PLANNING REPORT

Planning and Zoning Commission

Rings Road Mixed-Residential 26-025INF

Case Summary

Proposed Site Plan

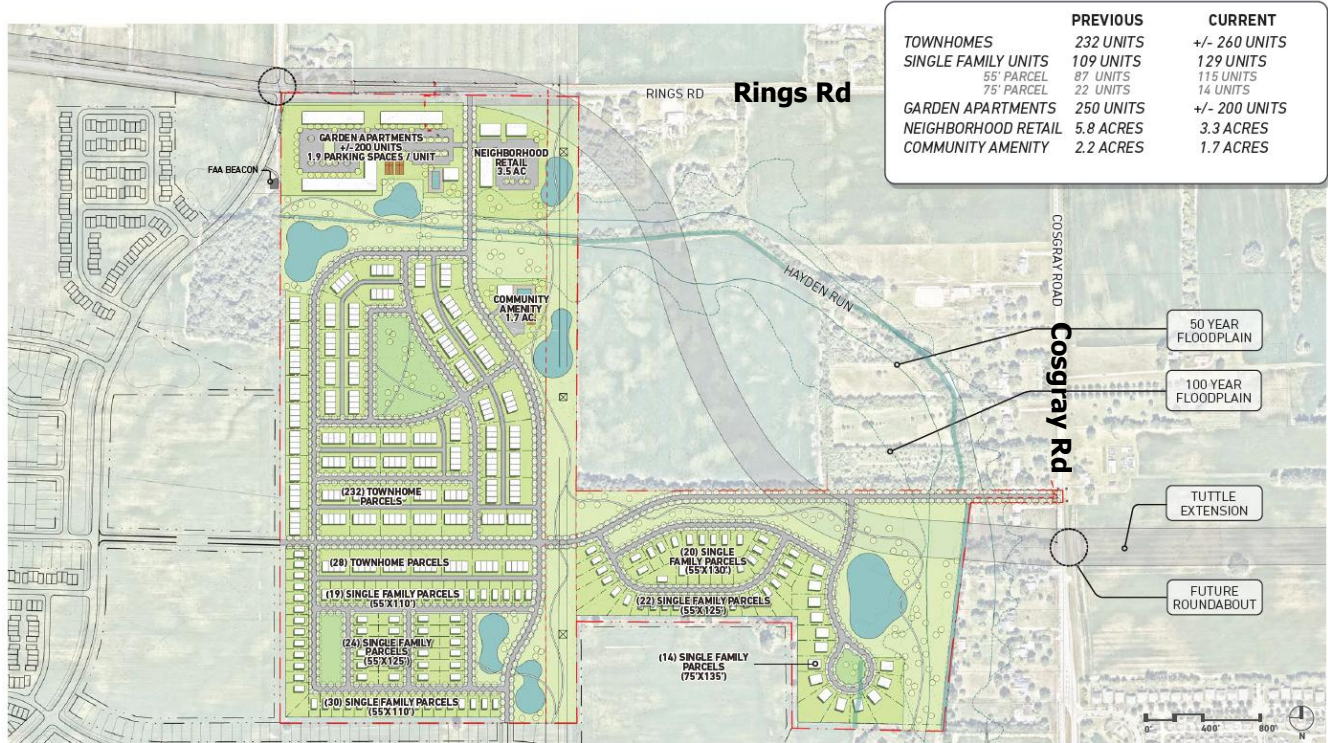
The proposed development is shown at a density of 4.29 residential units per acre. More dense multi-family units are proposed in the northern portion of the site adjacent to future flex innovation land along Rings Road. Single family and townhome lots are provided to the south for most of the site. This density is significantly lower than adjacent future development in Columbus (7.57 du/ac for Jameson Estates; 8.57 du/ac for Hayden Place). These densities do not contemplate additional land uses proposed in any of the developments. The Envision Dublin Community Plan provides recommended densities and land uses for land outside the Dublin corporate limits as part of the Future Land Use Plan. The densities for the adjacent developments are significantly higher than what was contemplated in the Envision Dublin Community Plan, which showed low density residential transitioning to more rural land.

The proposal includes 4 different single-family lot types, ranging from 6,050 square feet to 10,125 square feet. The development also would include attached townhomes throughout the center of the site, and garden apartment buildings along Rings Road to the north. The smaller single-family lots are in close proximity to the townhome units but are not fully integrated together throughout the development.

The residential building types align with the recommendations of the FLU plan, but additional opportunities to integrate the different unit types together throughout the site should be considered. The Commission should consider whether the proposed residential types are appropriate for the site, consistent with the recommendations of the Community Plan, and properly integrated with each other throughout the site.

The development is generally separated into 3 sections. The northern section of the site features the densest uses along Rings Road and the future Tuttle Crossing Blvd. (garden apartments and neighborhood retail). The western and southwestern portions of the site are dedicated to smaller-scale residential lots and townhome units, as well as a community amenity space east of the townhomes. The southeastern section of the development is dedicated to a variety of medium-to-larger lot single-family parcels. The sections are connected by both public open spaces along the overhead electric transmission lines and the Hayden Run. The applicant has provided neighborhood boulevard streets as the north/south and east/west spines of the development, both of which would connect the development to adjacent development, as well as Rings Rd. and Tuttle Crossing Blvd. Shared street typologies are proposed as frontage for both the single-family and townhome units throughout the development, with public service streets providing rear access to the townhome units in the development.

With the additional study of Tuttle Crossing Blvd. proceeding this year, the applicant will need to work with Staff to assure the development coordinates with any updated alignments for the street. The applicant would need to work with Staff to determine which portions of Tuttle Crossing Blvd. will need constructed as part of the development. This will include where streets are anticipated to intersect with the corridor, and where development occurs in proximity to the street. The layout of Tuttle Crossing Blvd. will also impact the developability of a portion of the adjacent site east of the proposed development and west of Tuttle Crossing. The applicant will need to consider how this development can connect to surrounding property to create a cohesive neighborhood.

The proposal consists of 44.8 acres of open space, which accounts for approximately 33 percent of the total site area. Open space is largely concentrated to existing natural features and the overhead transmission lines that bisect significant portions of the site. This creates a continuous open space corridor that connects the northwest and southeast corners of the development. The proposal also includes 3 plaza/park spaces integrated within the residential areas, ranging from 3 acres to 0.4 acres. Stormwater basins are also spread throughout the development and are anticipated to be activated within open spaces. All the open space within the development is accessible and located either along a street or accessible to the fronts of units.

Site Features

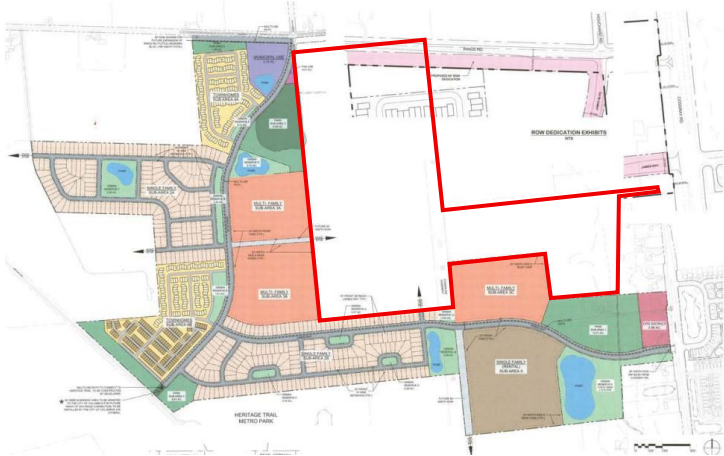
Hayden Run is a small stream that traverses through several properties south of Rings Road. A floodplain map is provided on the right to show the protections around the stream. The blue represents the floodway, the red represents the 100-year floodplain, and the yellow represents the 500-year floodplain. Development is generally required to avoid building within these zones, primarily within the 100-year floodplain and floodway. Additional study of the floodplain boundaries would need completed should the development proposal move forward.

Aside from the creek, the site is generally flat and does not include a significant amount of mature vegetation. As indicated by the blue dashed line, overhead electrical transmission lines go through the center of the site.
